CITY OF NOVI CITY COUNCIL JULY 22, 2024

Approval of the request of DTN Management/Tricap Holdings for JSP18-10 The Bond development for a Third Amendment of the Development Agreement, and revised Preliminary Site Plan, Storm Water Management Plan and Woodland Permit, to allow 69 additional units. The Subject Property is zoned Town Center One and is approximately 7.99 acres of vacant land in Section 22.

PLAN REVIEW CENTER REPORT

Revised Preliminary Site Plan

<u>Sheet L1.00:</u> Removed 2 landscape islands at ends of parking structure. Added new parking spaces and landscaping areas at ends of parking structure. Please see Revised Site Plan for revised layouts in these areas.

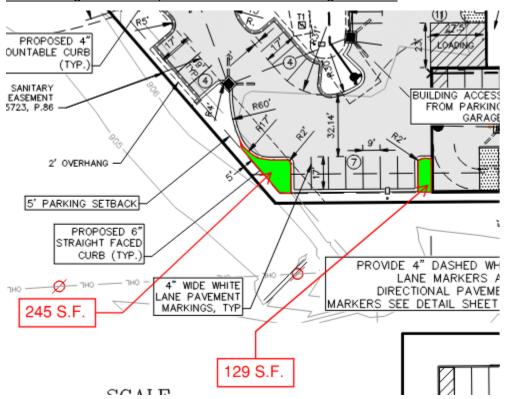
As requested in the Planning Review letter, the Landscape areas that will be revised have been marked up in red as follows:

New Parking and Landscape Areas North of the Parking Structure:

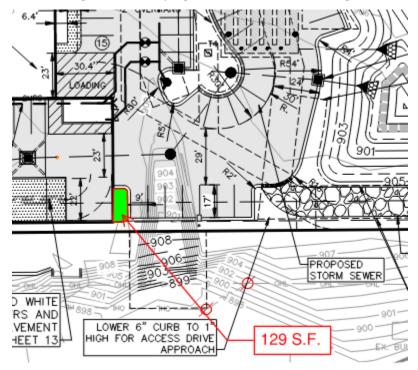
<u>Sheet L2.00:</u> Close up view of the landscape island to be removed and new parking areas at the north end of the parking structure.

New Parking and Landscaping Areas South of the Parking Structure:

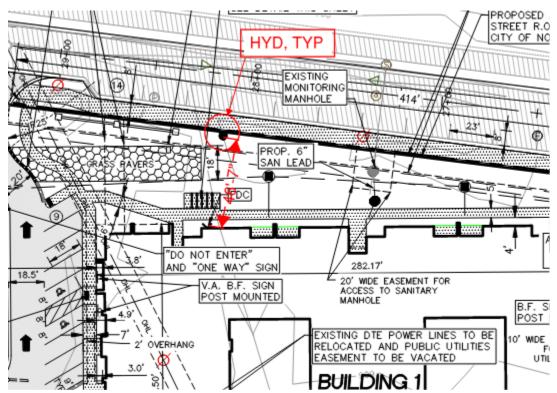
<u>Sheet L2.02:</u> Close up view of the landscape island to be removed and new parking areas at the south end of the parking structure.

It was noted by the Planning and Landscaping reviewers that the new landscape areas adjacent to the parking decks may be inadequately sized. These landscape areas can be increased in size by removing the adjacent parking space. This revision will be included in the Final Site Plan submittal, if required.
